# SERVICE BULLETIN

Service Bulletin No.: DA20-24-02, Rev. 0

Title: DC Generation, ( Improved Generator Grounding )

Figure 1 (Ref. DAI Drawing #20-2400-06-01, Rev. b)

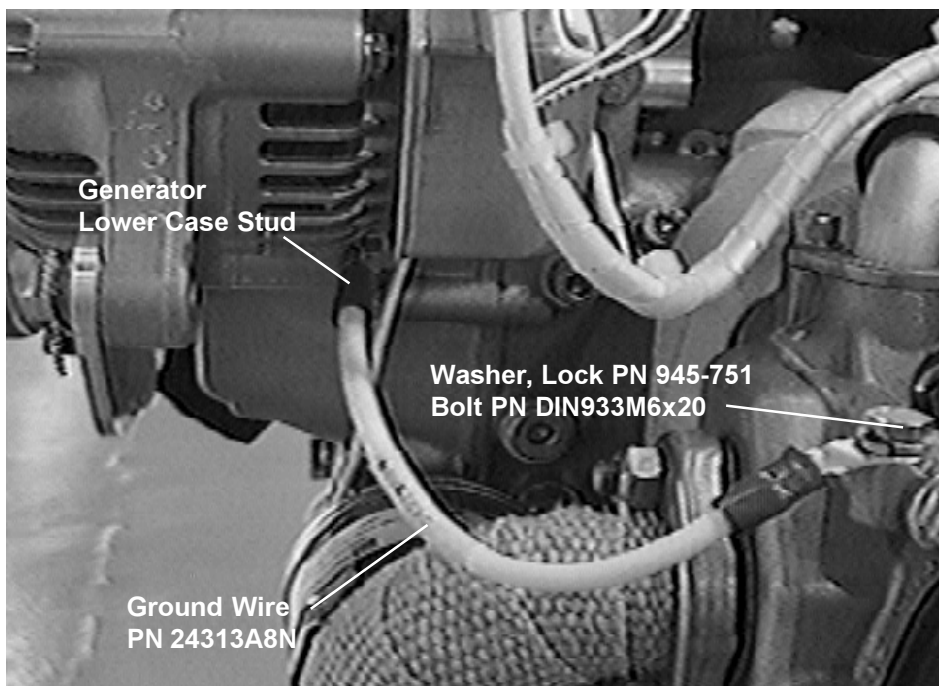
1. **ATA Code:** 2430
2. **Effectivity:** All DA 20 Katana Aircraft up to and including serial number 10045.
3. **General:** The ground return for the generator and generator fail indication is currently supplied through the generator mounting brackets. The addition of a chassis grounding wire from the generator directly to the engine is required to ensure adequate grounding.
4. **Compliance:** Incorporation of this Service Bulletin is highly recommended by Diamond Aircraft and should be accomplished at the operator's earliest opportunity.
5. **Approval:** Engineering data referenced or contained in this bulletin is Transport Canada approved.
6. **Labor:** Approximately 0.5 man hour.
7. **Material:**

- 10.2 Ensure all electrical contacts areas are clean.
  - 10.3 Remove lower case bolt from generator. Place the lower case bolt through the grounding wire ring terminal and re-install the bolt into the generator housing.

- 10.4 Place the supplied bolt and lock washer through the grounding wire ring terminal and install in the # 2 cylinder head casting threaded hole located on the top forward outboard part of the cylinder.

- 10.5 Route the wire clear of the exhaust pipe.
  - 10.6 Ensure the engine compartment is clear of foreign materials and re-install the engine cowlings.
